HUNTS POINT INTERSTATE ACCESS IMPROVEMENT PROJECT – CONTRACT 3

PIN X731.65, Contract D900055

Addendum #8

July 22, 2022

INDICATIVE PLANS
WORK ZONE TRAFFIC CONTROL
STAGE 1
BRIDGE
SHEET 3

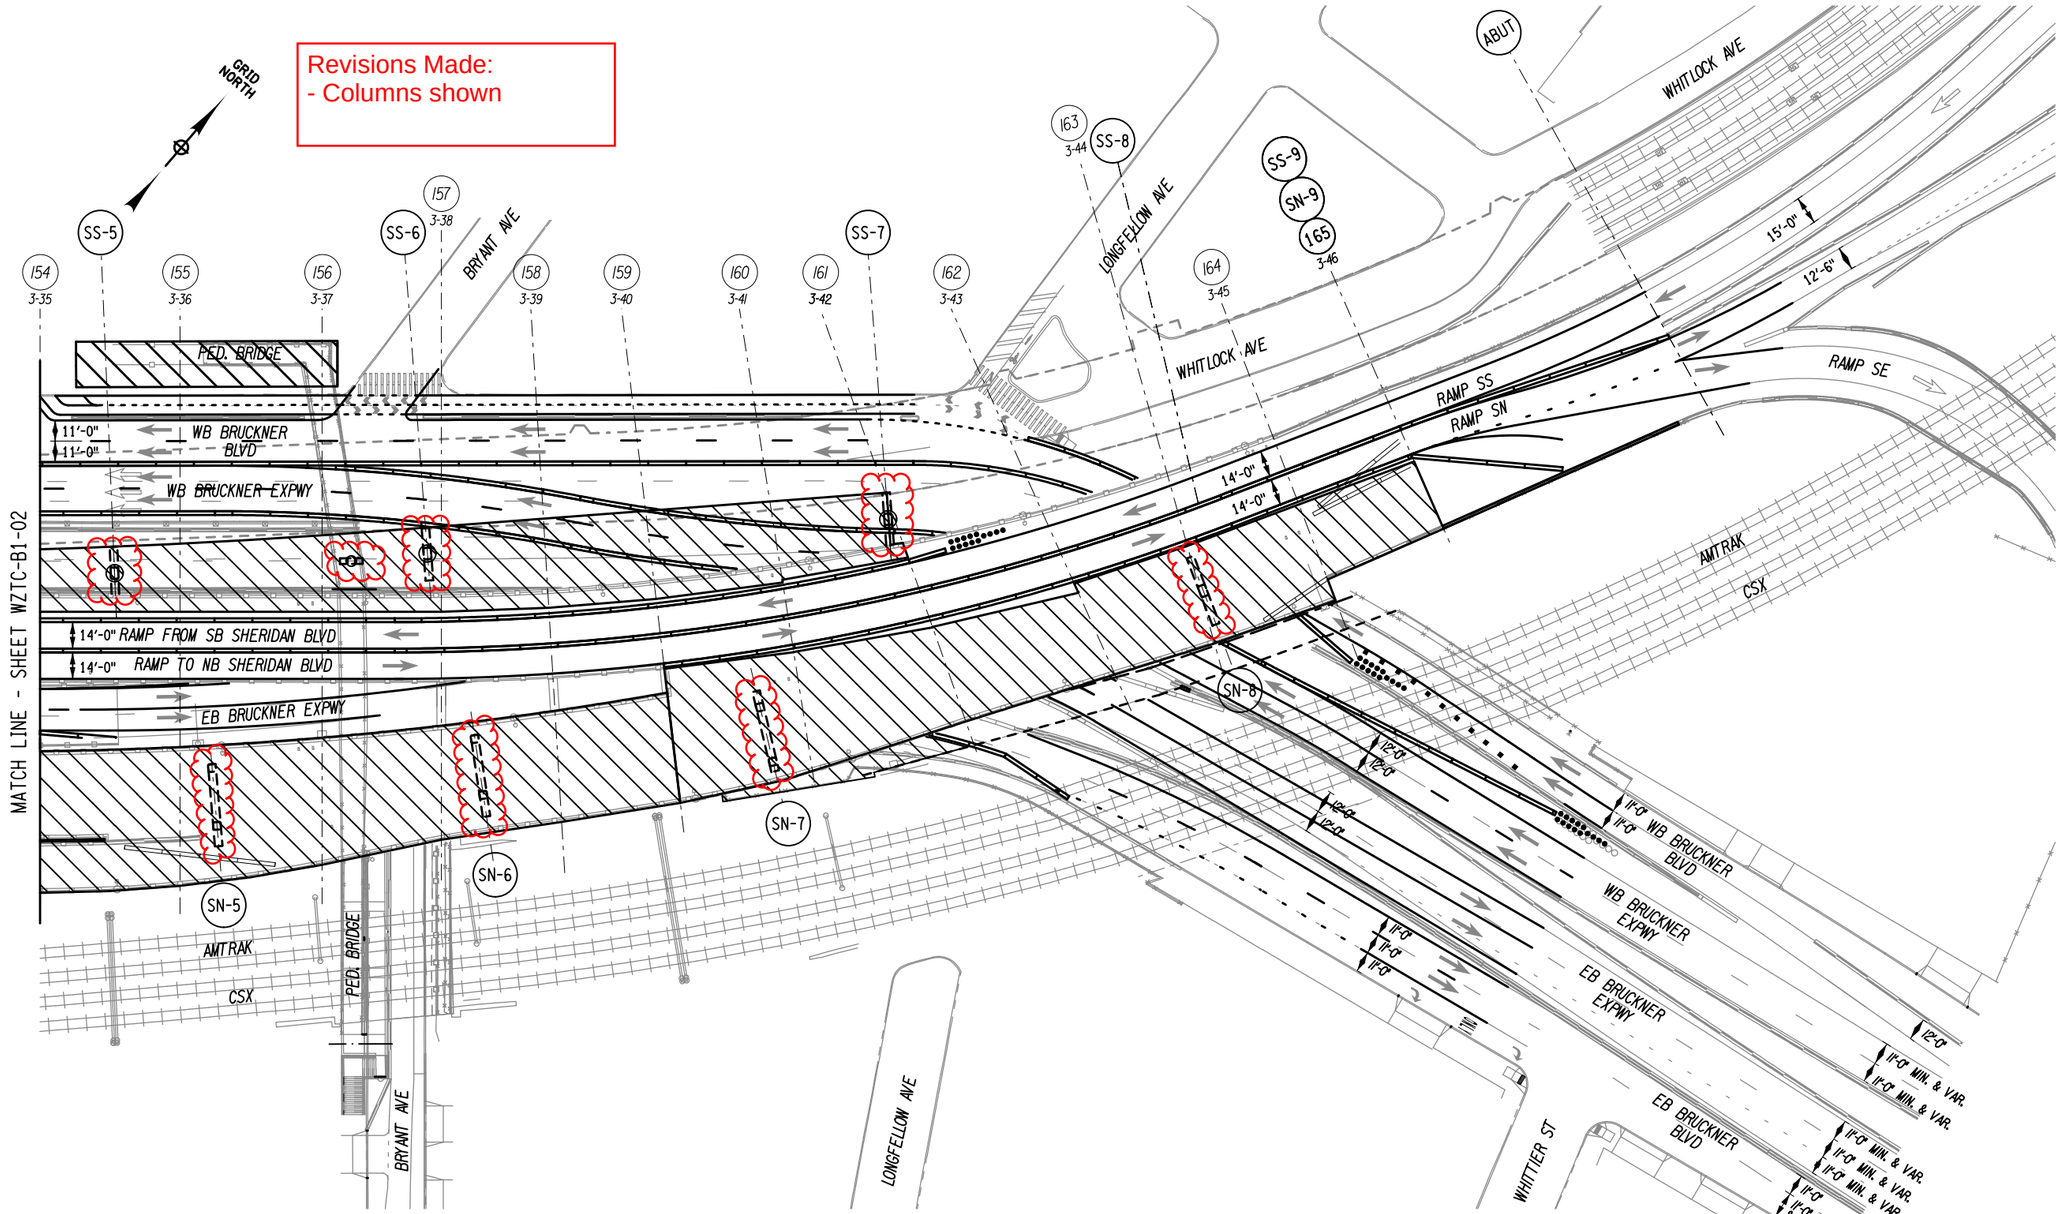
Revisions Made:
- Columns shown

INDICATIVE PLANS
WORK ZONE TRAFFIC CONTROL
STAGE 1-1
AT-GRADE
SHEET 2

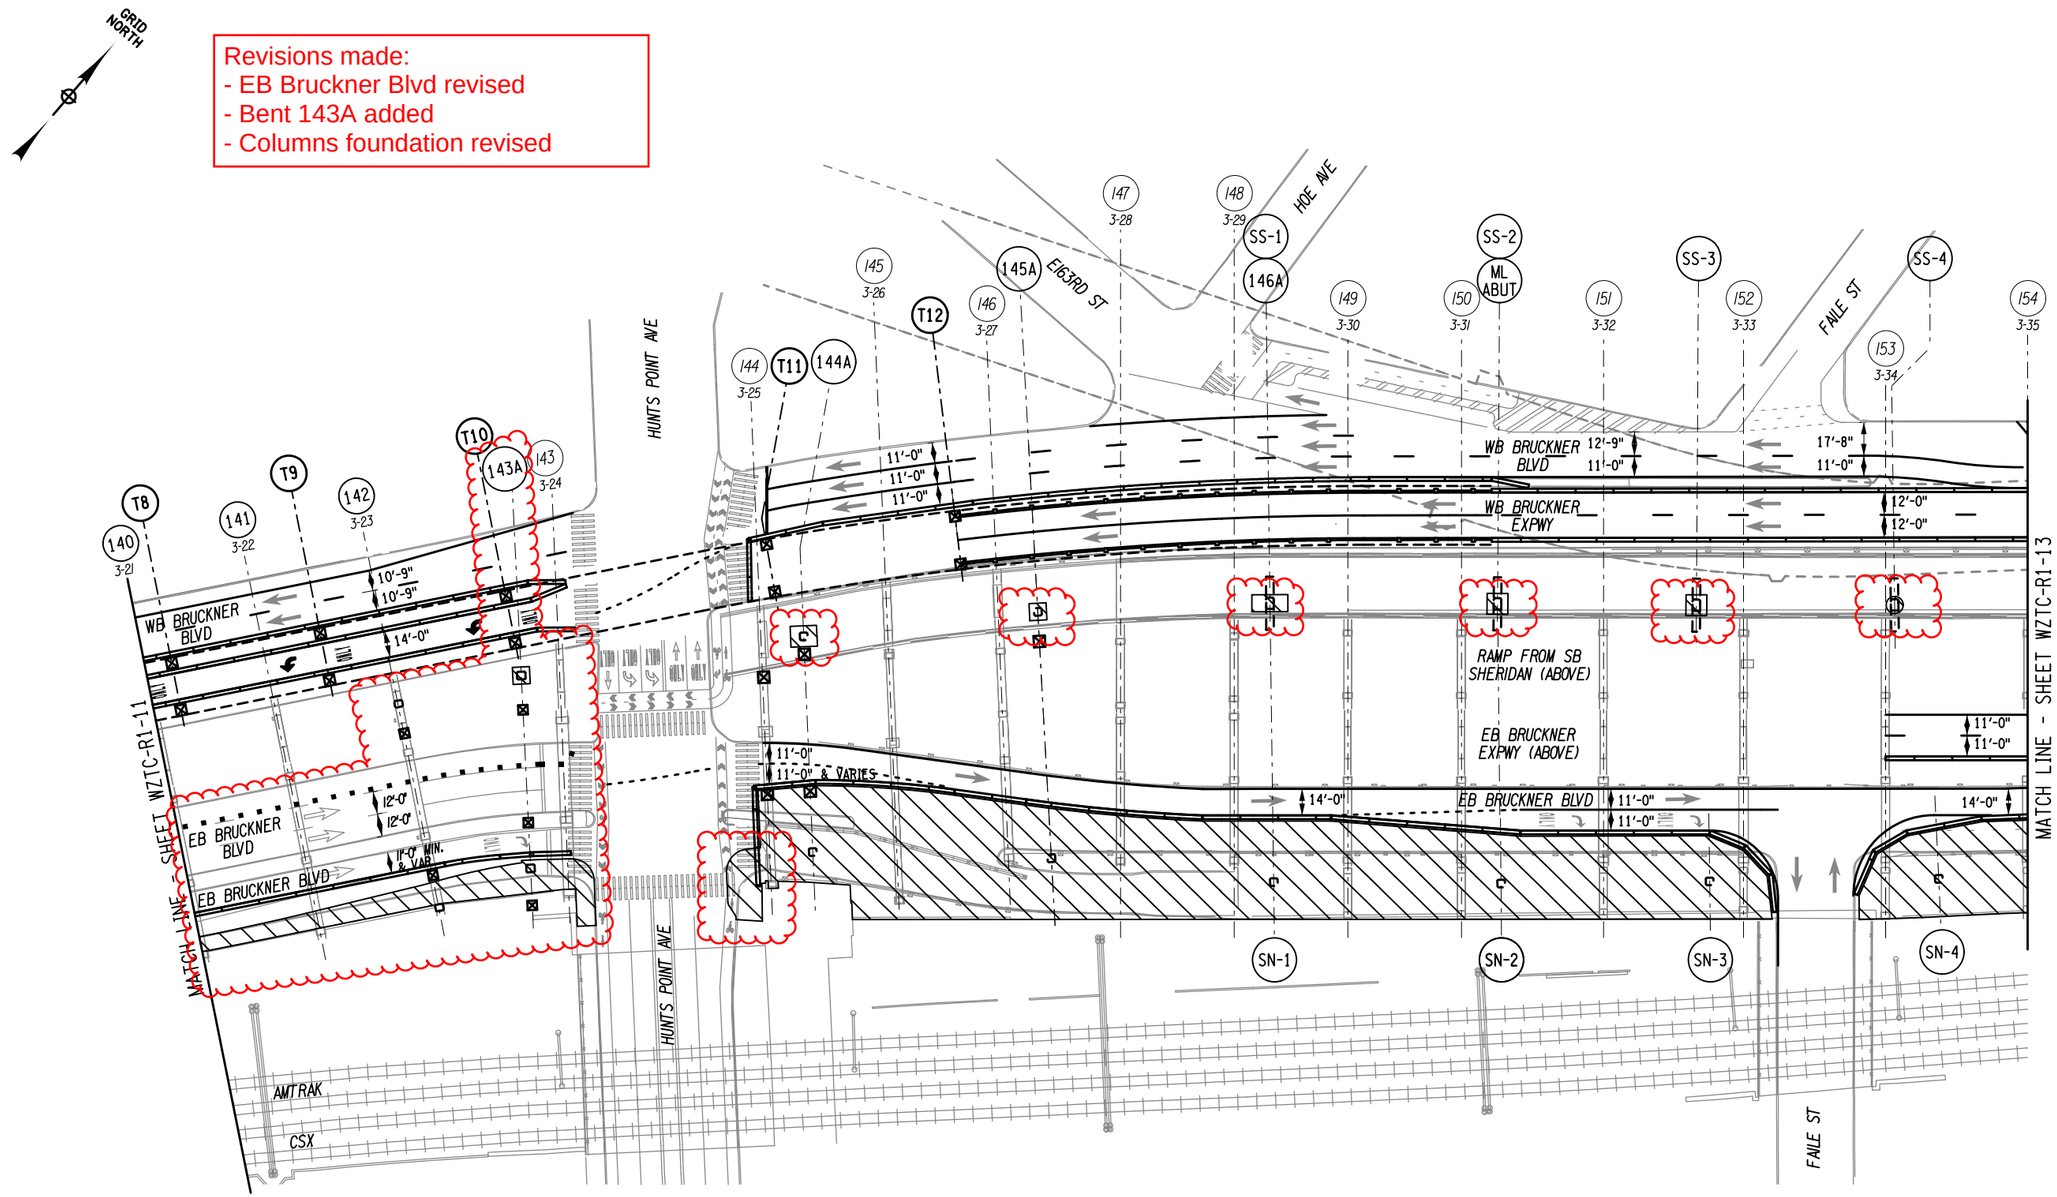
Revisions made:
- EB Bruckner Blvd revised
- Bent 143A added
- Columns foundation revised

INDICATIVE PLANS
WORK ZONE TRAFFIC CONTROL
STAGE 1-1
AT-GRADE
SHEET 3

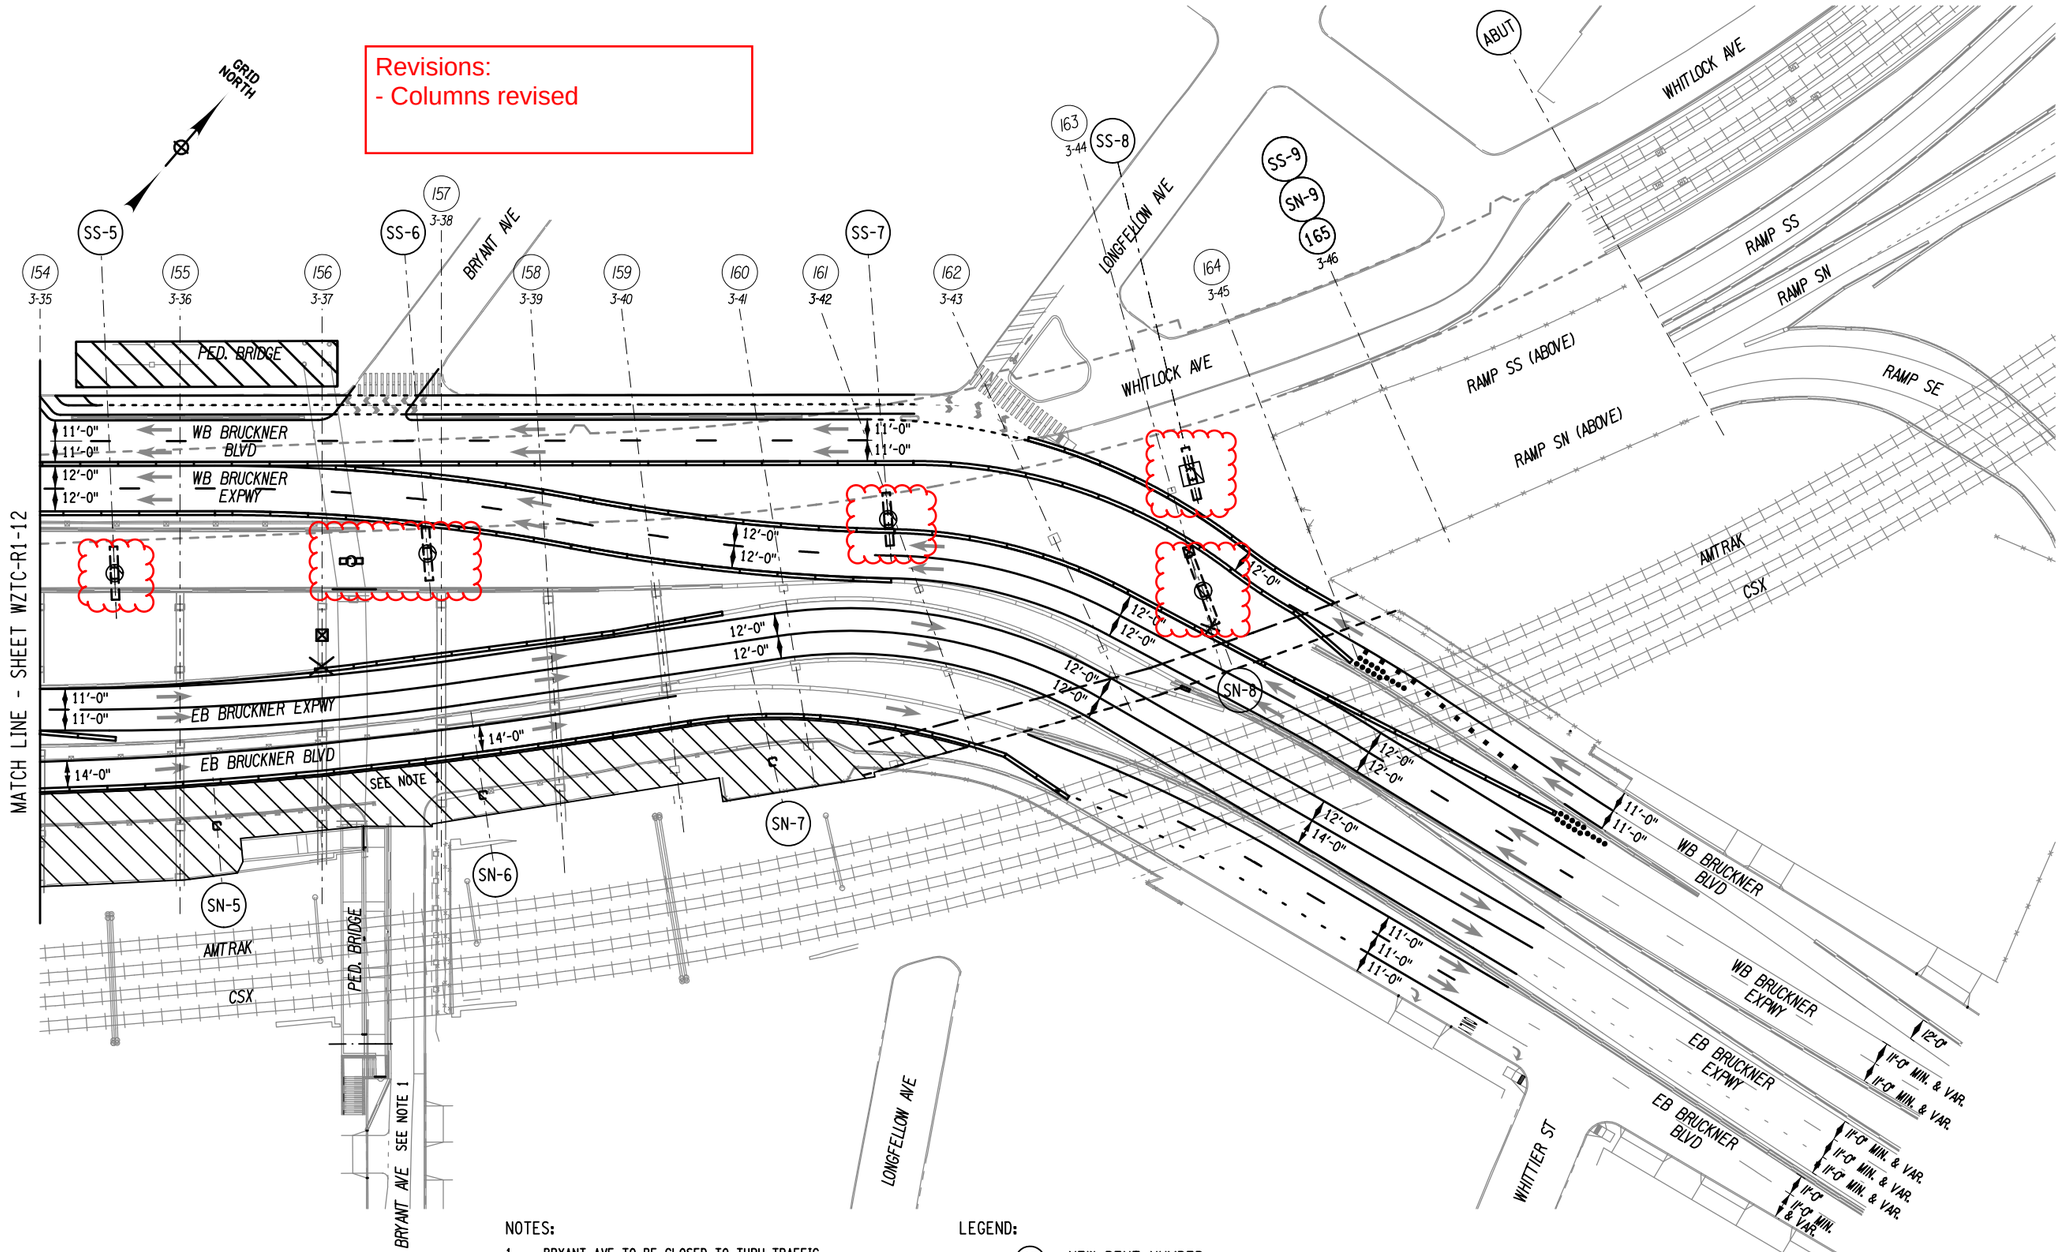
Revisions:
- Columns revised

INDICATIVE PLANS
WORK ZONE TRAFFIC CONTROL
AT-GRADE
STAGE 1-2
SHEET 2

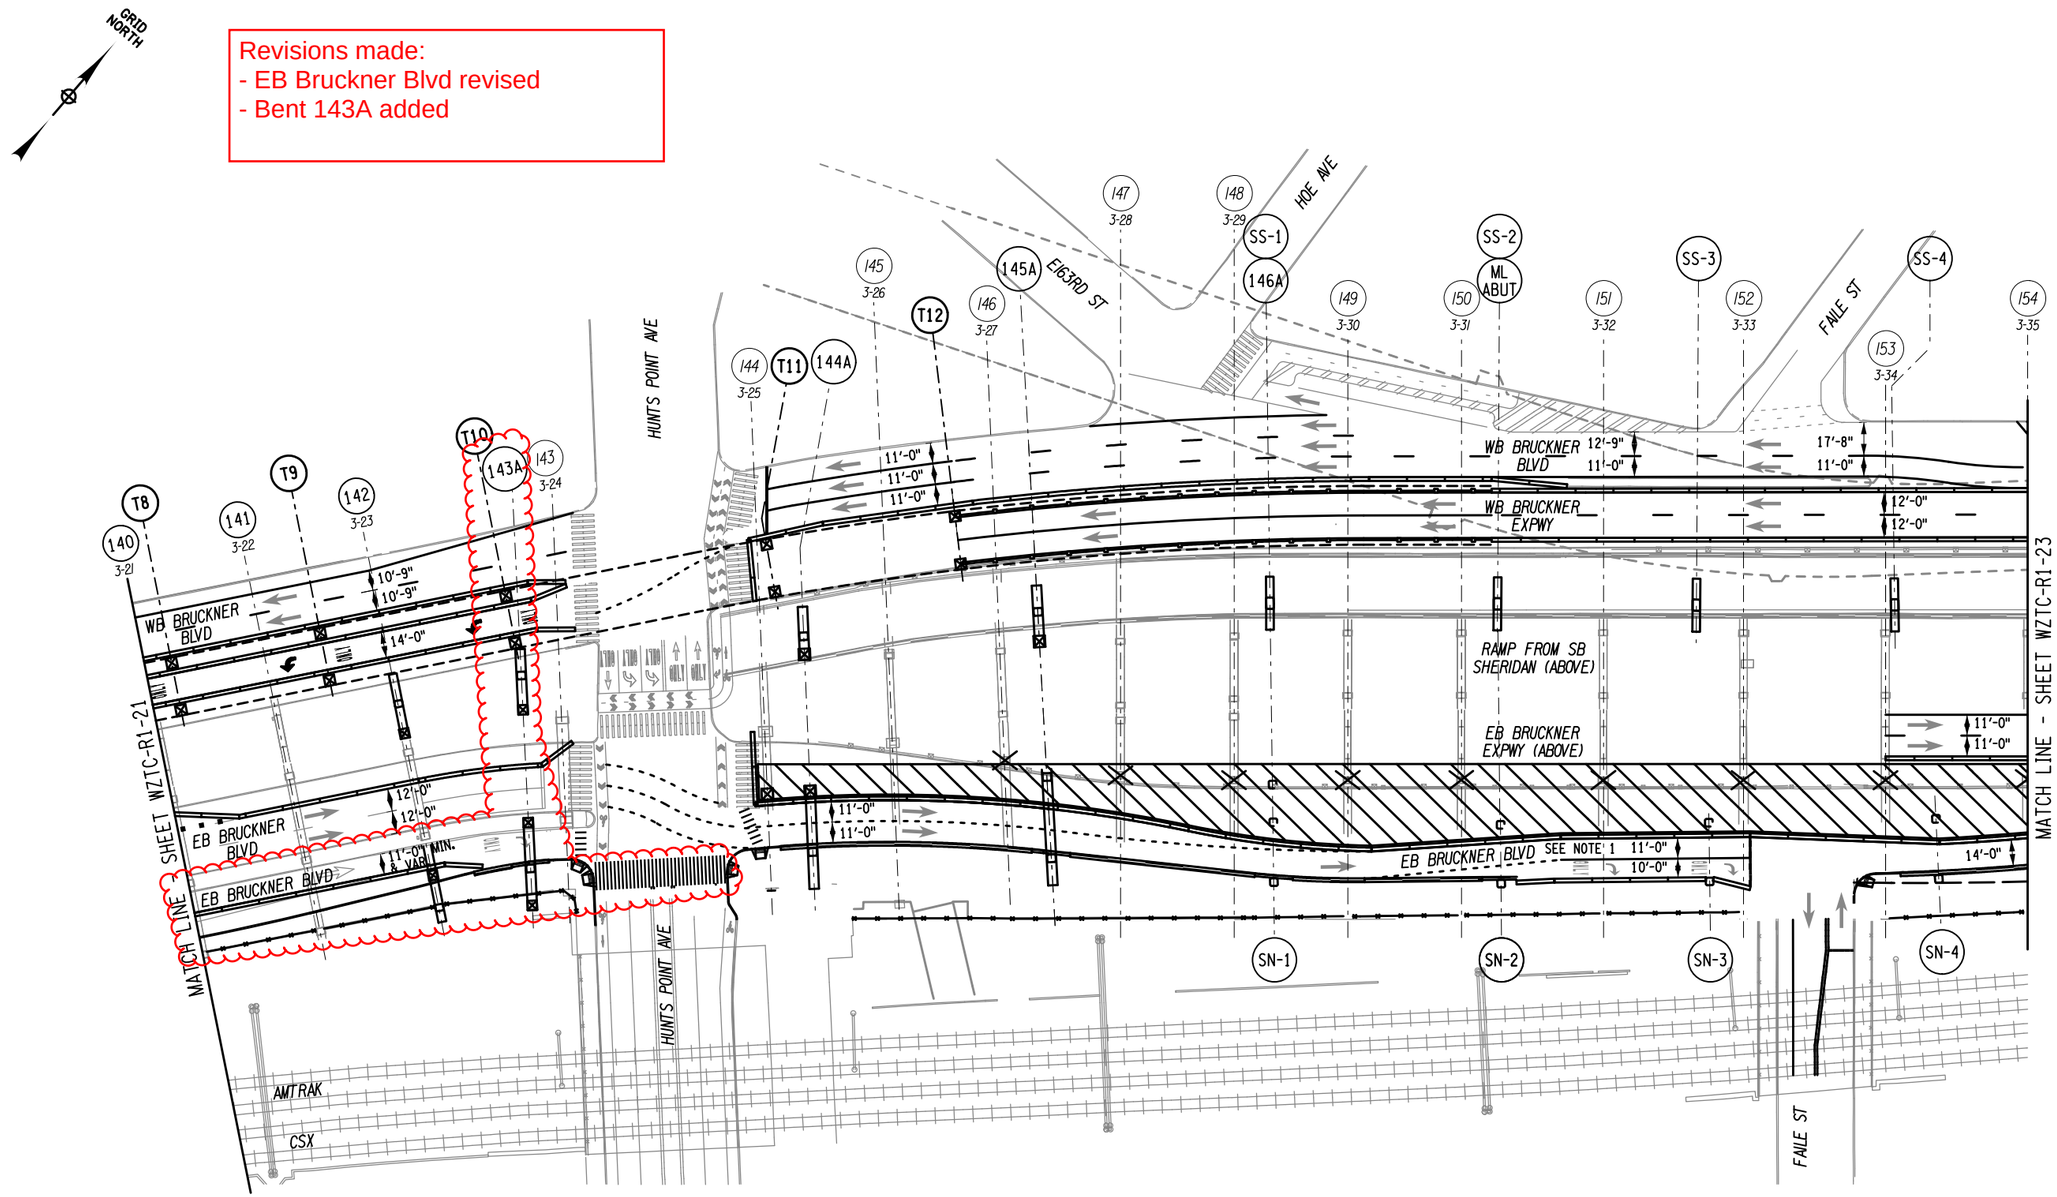
Revisions made:
- EB Bruckner Blvd revised
- Bent 143A added
